Indian Point Energy Center  
450 Broadway, GSB  
P.O. Box 249  
Buchanan, N.Y. 10511-0249  
Tel (914) 734-6700

NL-10-093

Subject: **Indian Point Nuclear Power Plant Units 2 and 3  
Response to Request for Additional Information regarding the Inter-Unit  
Spent Fuel Transfer License Amendment Request (TAC Nos. ME1671,  
ME1672, and L24299)**  
Indian Point Units 2 & 3  
Docket Nos. 50-247 and 50-286  
License Nos. DPR-26 and DPR-64

Figure 1B: HI-TRAC LS-DYNA Tipover Model – Impact Orientation 2

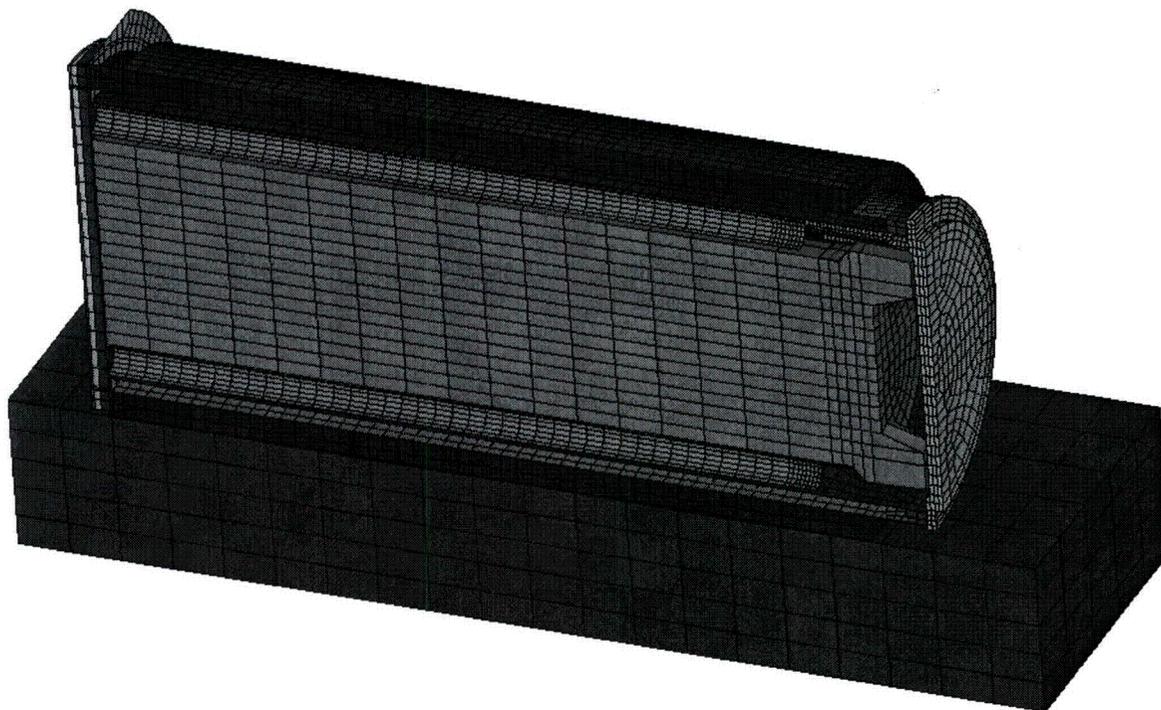
The analyses can be based on a non-mechanistic tipover over the lower corner onto a receiving surface (which bounds the characteristics of the haul path) from a position of balance, with no initial velocity. The analyses should also address confinement integrity, thermal-hydraulic response, gaseous releases from fuel rods, which also affect the internal pressure, and variations in external dose rate and effects on STC emissions during such an event. Although the applicant has identified the crane, airpad, and vertical cask transport systems as components that preclude tipover, analyses are needed to provide defense-in-depth of the safety of the cask transfer system. Additional guidance on acceptable methods of tip-over analyses is provided in NUREG-1536.

If the assessment demonstrates the STC cannot maintain confinement under such an event, the STC should be redesigned such that confinement is maintained. The consequence assessment will provide insights on the level of confidence (including rigor of license condition design controls and operational controls) that is needed to assure that tipover will be precluded (i.e. low likelihood), as currently maintained by the applicant.

To enable the transfer cask to meet the above set of structural criteria, an internal impact limiter has been incorporated in the design. This impact limiter, shown in licensing drawing 7591, consists of an assemblage of aluminum tubes arranged in a weldment configured to occupy the annular space between the STC and the HI-TRAC cylindrical cavity and sized to center the STC inside the HI-TRAC. The thickness of the aluminum tubes was established by iterative tip-over simulations on LS-DYNA.

Figures 1A and 1B show the two limiting configurations considered for the Tip-over analysis. The details of the analysis and corresponding results are presented in Chapter 6, Section 6.2.8.

Figure 3.4-1

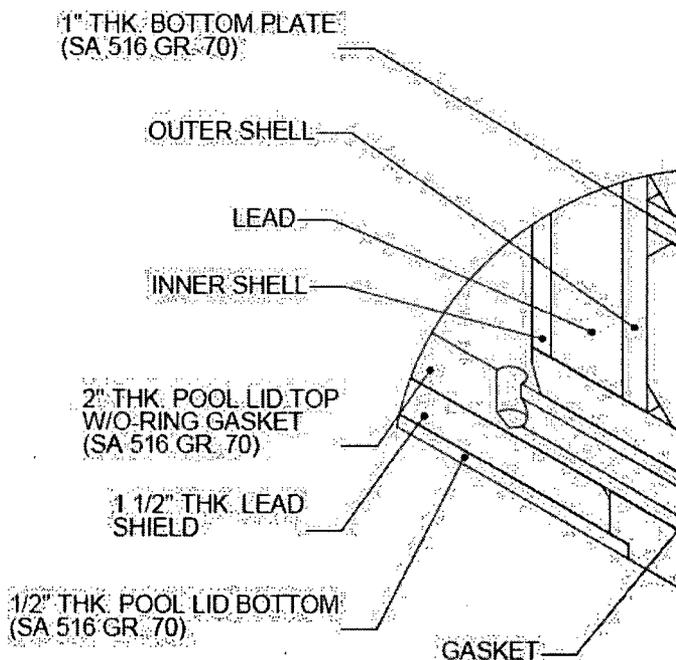
Justify the tornado missile event for the HI-STORM 100 system, as bounding for the IP Fuel Transfer (refer to Table 1.3 in Entergy's Response with Supplemental Information (RSI), dated September 28, 2009.)(SMMB).

Staff notes that the applicant considers that, "ensuring that the annulus water is not lost is a central objective in the system design," as indicated in RSI response 1.b. Analyze the effect on an immobilized STC/HI-TRAC system with a breached outer transfer lid door, and the consequent loss of annulus water if the STC is immobilized outdoors for 30 days due to a transport problem.

HI-STORM 100 FSAR (Revision 4 of Report HI-2002444, Section 3.4.8.2.1) indicates an intermediate tornado missile strike will penetrate through the outer transfer lid door of the base HI-TRAC 100 transfer cask design. Note that this does not indicate that the intermediate missile penetrates through the entire thickness of the transfer lid, only the outer transfer lid door. However, the HI-TRAC 100D used at IPEC does not employ a transfer lid. Instead, the HI-TRAC 100D has a pool lid which performs a dual function in the HI-TRAC 100D design in the dry storage application (see the response to RAI 1-2). Therefore, the missile analysis referred to in this RAI does not apply to the HI-TRAC 100D design.

During the inter-unit fuel transfer, the HI-TRAC 100D will be equipped with the pool lid as indicated on Holtec drawing 4128 Sheet 4. Unlike dry storage cask loading operations, the pool lid remains in place during the entire inter-unit fuel transfer campaign.

To clarify this statement, the pool lid as depicted on Sheet 1 of Holtec drawing 4128 (excerpted in Figure 3.4-1 below) is made of three layers: 1) the “pool lid bottom” made of 0.5 inch thick SA 516, Grade 70 steel plate, 2) a 1.5 inch thick lead plate, and 3) the “pool lid top” made of 2.0 inch thick SA 516, Grade 70 steel plate. The intermediate tornado missile analysis shows that the missile penetrates the pool lid bottom, but it does not penetrate the lead plate and pool lid top. Therefore, a breach of the HI-TRAC 100D pressure boundary due to a tornado missile strike on the pool lid, resulting in a loss of annulus water, will not occur.

It is also important to note that the HI-TRAC 100D when used for the inter-unit transfer, will be equipped with a bottom missile shield (BMS- drawing 7161). The BMS is designed to protect the pool lid flange and lid bolted connection during a tornado missile event. In addition, the BMS will also protect the HI-TRAC 100D drain which will be plugged during the inter-unit transfer. Also, during transfer operations, the orientation of the HI-TRAC 100D and the height of the pool lid from the ground makes a direct missile strike on the pool lid bottom highly unlikely.
